Subject:	AE Proposed Rules Changes		Annex:	15
Author(s):	Ronald Overdijk, AE committee chair		Agenda ref.:	13.3
Authors representing:			Doc. nr:	1
Date:		Repl. doc. dated / version:	N/A	Page 1 of 3

Proposals for changes to competition rules AE 2005

Freely compulsory (speed) round score chart

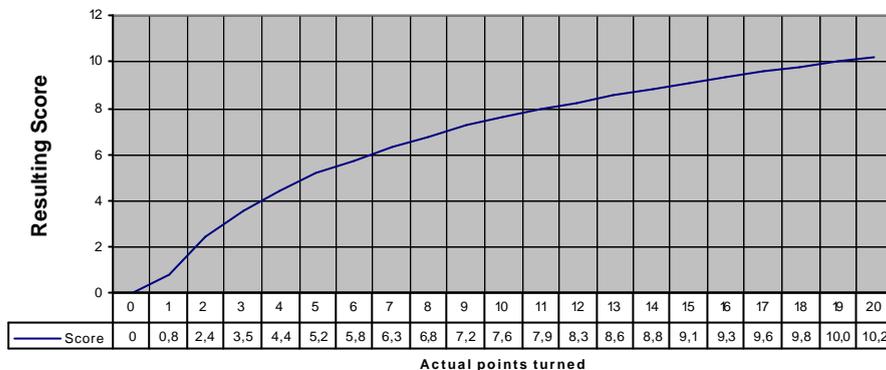
5.12.1.7. The calculation of scores are shown in a graphic as follows:
